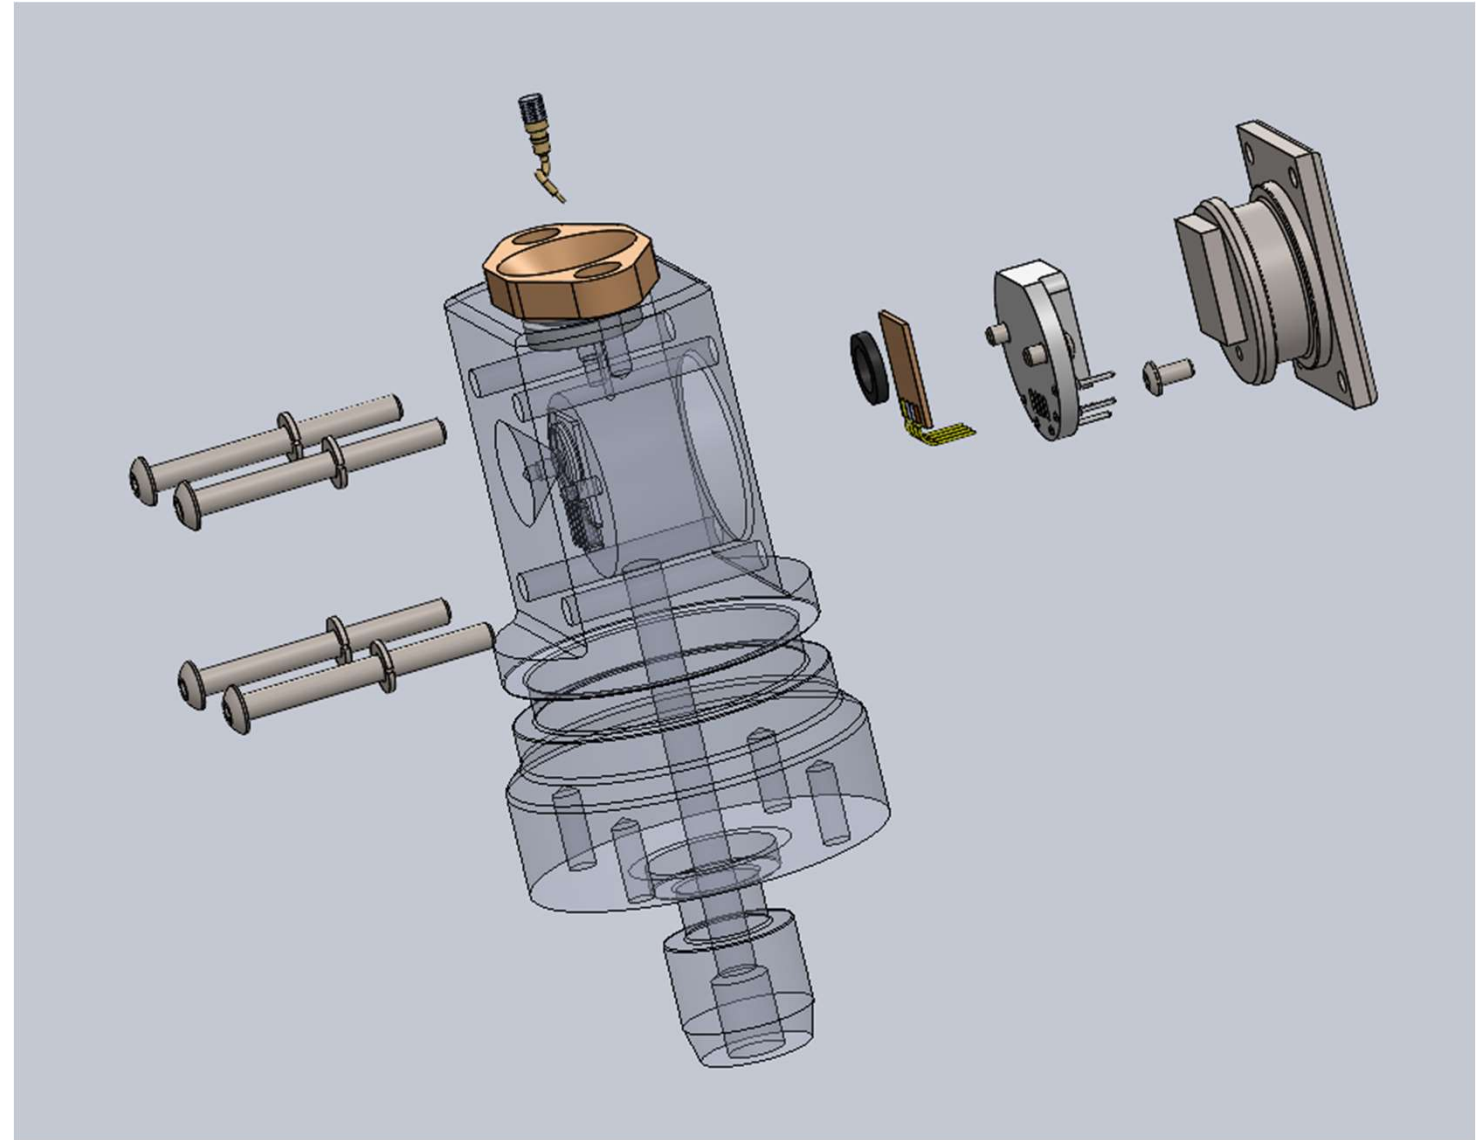
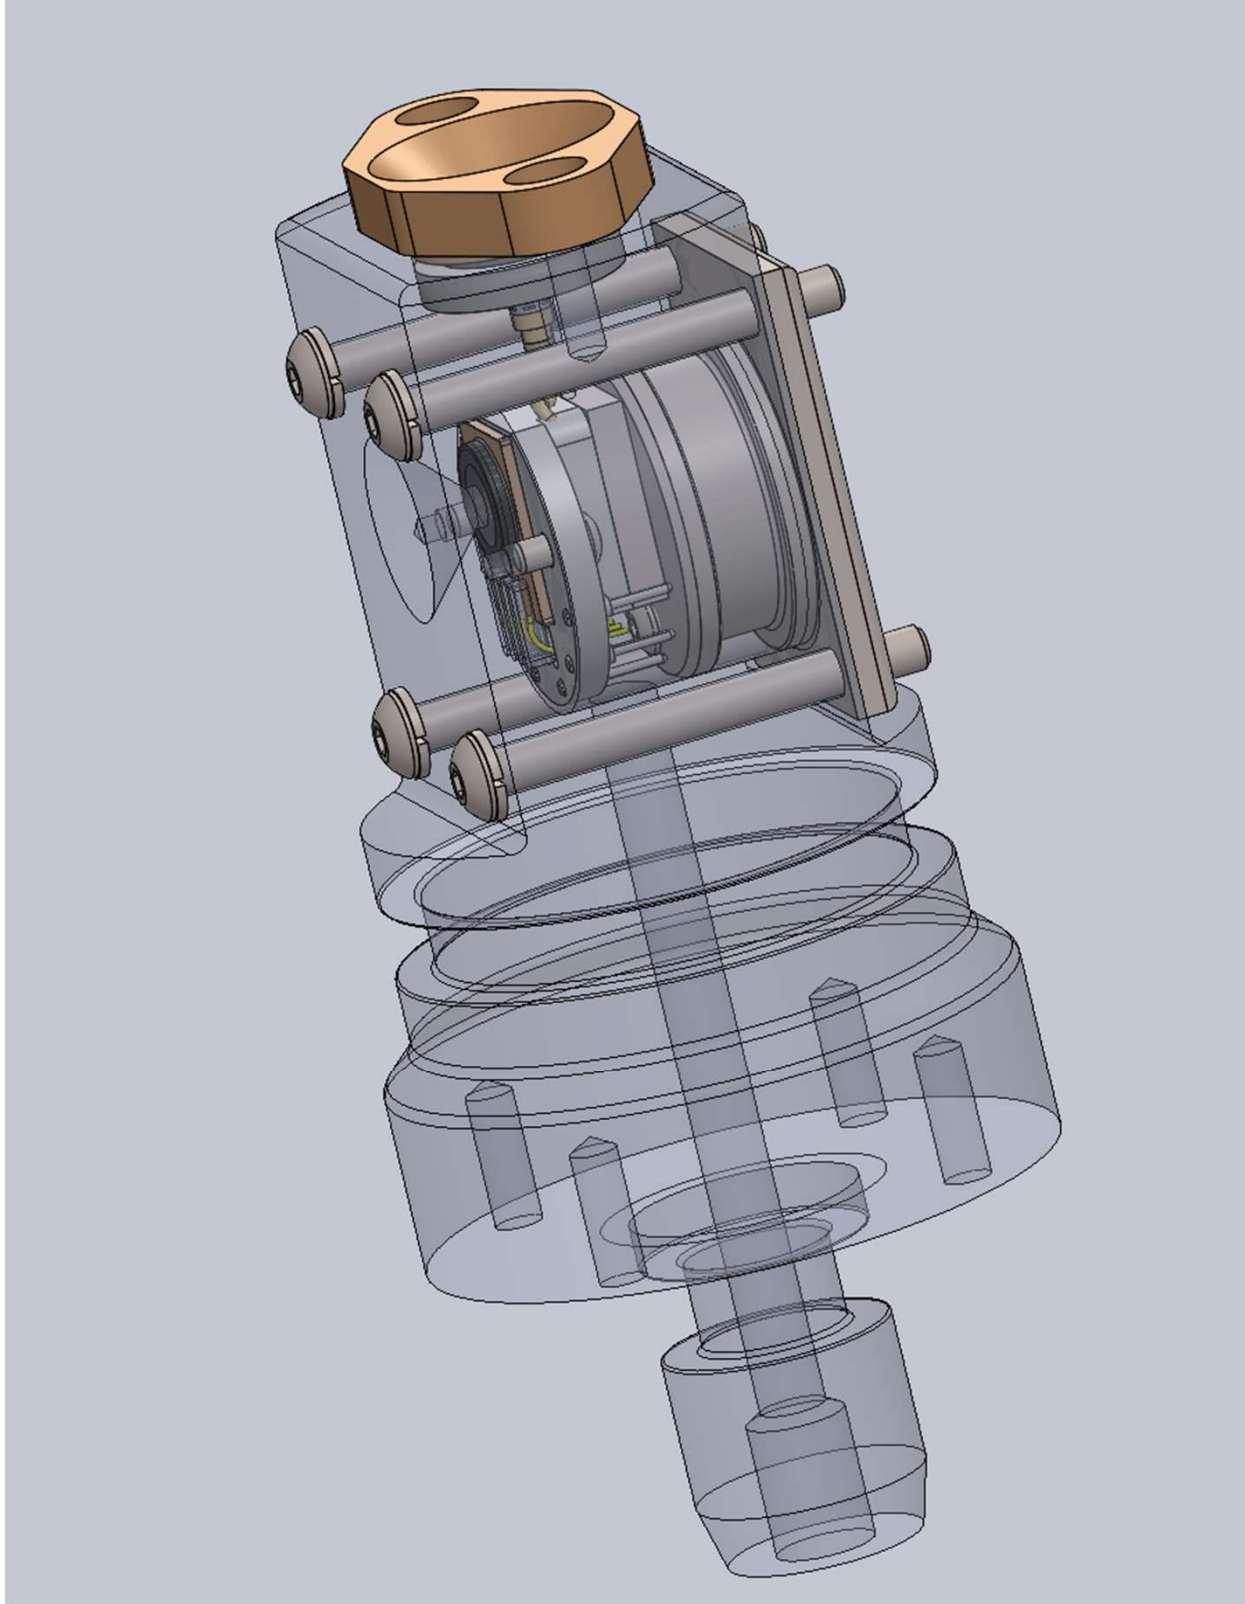
1. No front cover plate so no shoulder/no-shoulder decision
2. Either VL pellet cover will work
3. Still some risk associated with real-world manufacturability that we can probably only answer by building one.
